# Access Compliance Report

## Public Rights-of-Way

### (Curb Ramps)

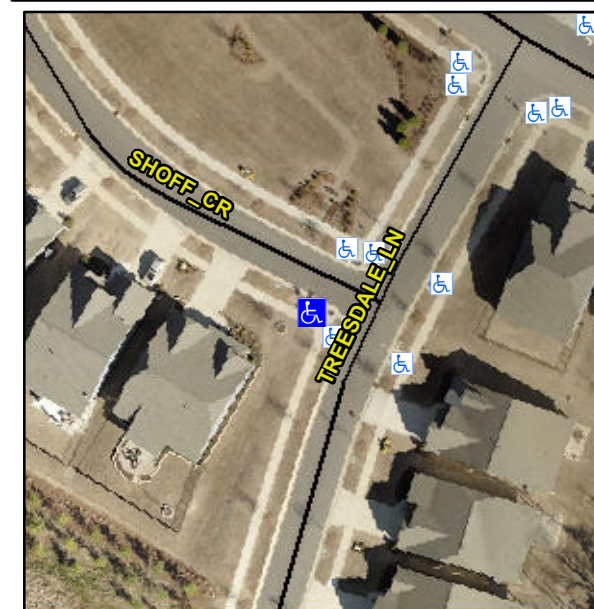
Intersection ID: N/A	Main Street: TREESDALE LN	Cross Street: SHOFF CIR	Location: W
ADA ID: 609C073201E7	Ramp Type: Perpendicular	Initial Pass/Fail: Fail	Overall Compliance: No
Severity Score: 1.25			
Codes/Mitigation Info/Possible Solution		Field Measurements/Component Compliance

**Not Found, R304.5.3**

Compliance	Description	Data	Compliance	Description	Data
N/A	Ramp Length (in)	95.0	Yes	Ramp Slope (%)	7.2
Yes	Ramp Width (in)	48.0	No	Ramp XSlope (%)	4.2
N/A	Flare Type LT	N/A	N/A	Flare Type RT	N/A
N/A	Flare Slope LT (%)	N/A	N/A	Flare Slope RT (%)	N/A
N/A	Flare Traversable LT?	No	N/A	Flare Traversable RT?	No
N/A	Landing Length (in)	N/A	N/A	DWS Provided?	N/A
N/A	Landing Width (in)	N/A	N/A	DWS Contrast?	N/A
N/A	Landing Slope (%)	N/A	N/A	DWS Length (in)	N/A
N/A	Landing X Slope (%)	N/A	N/A	DWS Full Width?	N/A
N/A	Landing Curb? (Y/N)	N/A	N/A	DWS Offset (in)	N/A
N/A	Shared Landing?	N/A			
N/A	Gutter Ponding?	N/A	N/A	Gutter Slope (%)	N/A
N/A	Gutter Lip Ht (in)	N/A	N/A	Gutter X Slope (%)	N/A
N/A	Painted X Walk1?	No	N/A	Painted X Walk2?	N/A
	X Walk 1 Direction	To NE		X Walk 2 Direction	N/A
N/A	X Walk 1 Width (in)	N/A	N/A	X Walk 2 Width (in)	N/A
	X Walk 1 Slope (%)	3.0		X Walk 2 Slope (%)	N/A
	X Walk 1 X Slope (%)	3.8		X Walk 2 X Slope (%)	N/A

**Remove & Replace Entire Ramp.**
